<b>Technical Bulletin</b>		
<b>No: TB075</b>	<b>Rev: 0</b>	<b>Date: 10Feb2010</b>
<b>Elevator Link Bushing Upgrade 150T-EMI-400 Top Drive Systems</b>		 <p>Tesco Corporation 3993 W. Sam Houston Pkwy N. Suite 100 Houston, Texas 77043 Phone: (713) 359-7000 <a href="http://www.tescocorp.com">www.tescocorp.com</a></p>

**Figure 1:** Elevator link in contact with gearbox and split block adapter

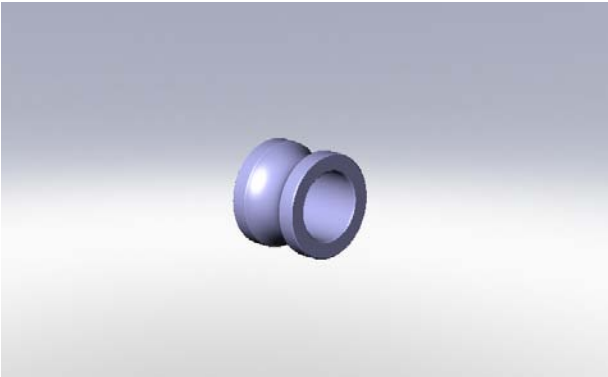
TESCO Engineering and the Quality Control department have carried out an investigation and identified incidents in the field where the current 150T-EMI-400 elevator link-tilt design (Figure 5) permits the elevator links to make contact with the gearbox/swivel and split block adapter during top drive operation (Figure 1). This results in the gradual wear to the components (Figure 2).

**Figure 4:** New elevator link bushing

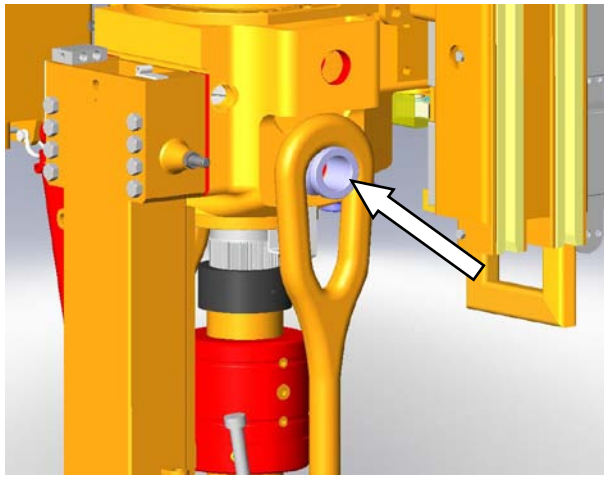
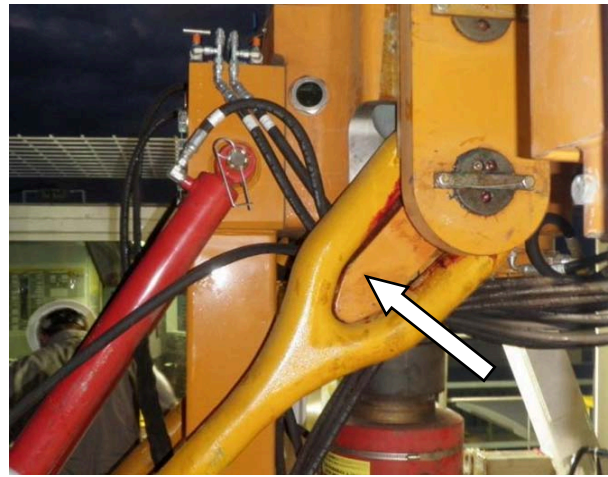
Although this will not immediately jeopardize the integrity of the top drive unit or affect the critical load path, TESCO has developed a new elevator link bushing (Figure 4) that ensures top drive operation will not be disrupted as a result of wear. The new elevator link bushing design restricts vertical movement of the elevator links (Figure 6), preventing them from coming into contact with the gearbox/swivel and split block adapter.

Visually inspect the gearbox and split block adapter for any wear. TESCO personnel can assist in identifying acceptable wear limits. TESCO Business Units and customers operating the TESCO 150T-EMI-400 Top Drive System are encouraged to upgrade their units to the new elevator link bushing design. The elevator link bushing design can be obtained through TESCO AMSS.
